URGENT FIELD SAFETY NOTICE**RE: SINGLE USE LIGATING DEVICE POLYLOOP****Attention:** Endoscopy Department, Risk Management

Material ID	Model Number	Material Description	Lot Numbers	UDI
N5382130	HX-400U-30	SINGLE USE LIGATING DEVICE POLYLOOP	All Lots	04953170368615

Attachment 1 - SINGLE USE LIGATING DEVICE HX-400U-30
Preventing Incorrect and Incomplete Loop
Detachment

Figure 1

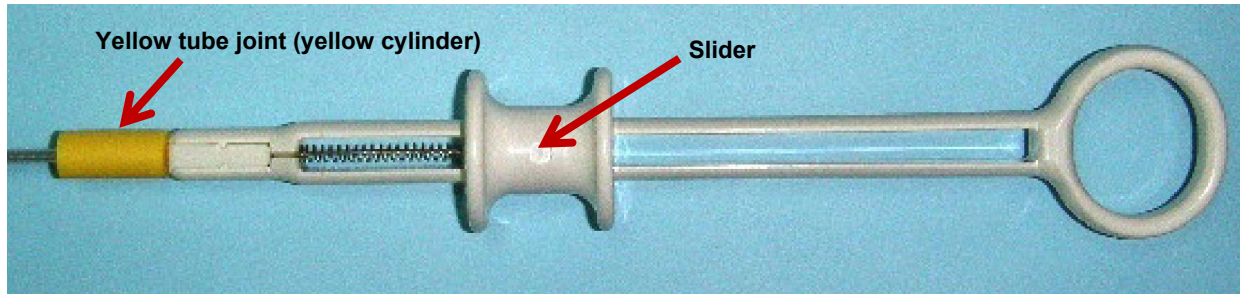
- Inadvertent or intentional movement of the yellow tube joint (cylinder) away from the device handle during use. Intentionally moving the yellow tube joint away from the handle to prematurely tighten the loop during use may cause the inability to release the ligation loop. (See figure 1 below.)
- Forceful advancement of the slider located on the device handle when resistance is encountered may cause an inability to release the loop.

■ **Do not hold the loop with the distal end of the tube sheath while the loop is surrounding the tissue. (refer to page 5 in the manual)**

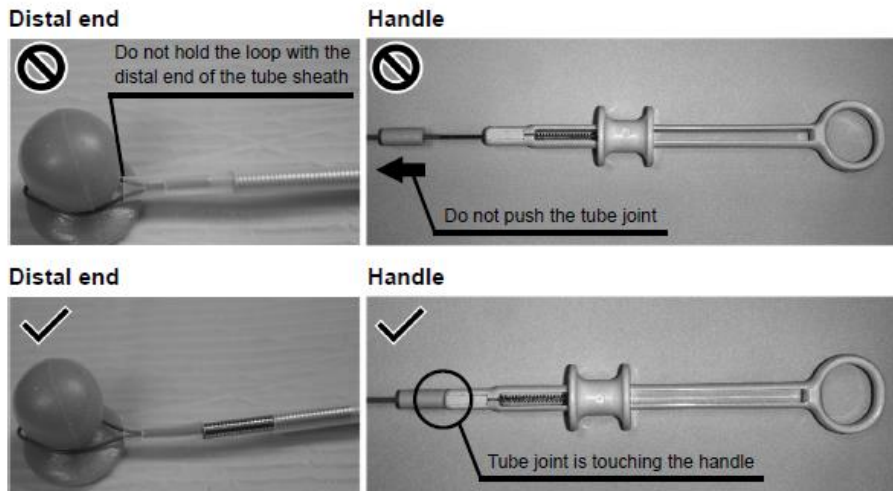
Otherwise, when the tissue is ligated, the loop may be detached from the hook in the tube sheath and tangled with the hook.

- **Do not remove the loop from the hook while the coil sheath is not extended from the tube sheath. (refer to page 6 in the manual)**

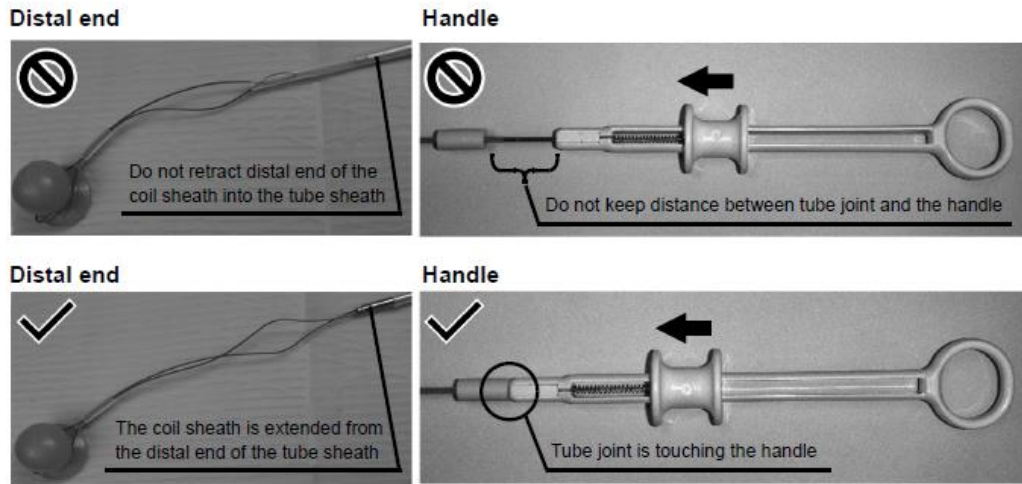
Otherwise, the loop may be tangled with the hook and become impossible to be removed.

- **With the proximal end of the tube sheath and handle kept straight against the biopsy valve of the endoscope, push the slider when detaching the loop. (refer to page 6 in the manual)**

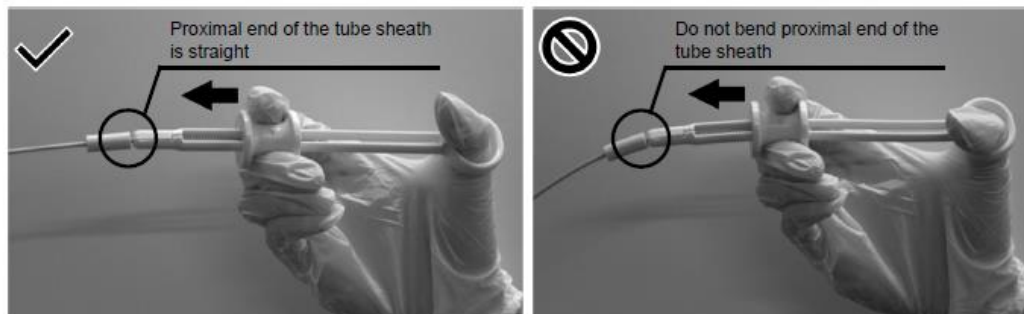
Bending the proximal end of the tube sheath will increase frictional resistance, which may damage the handle when pushing the slider.
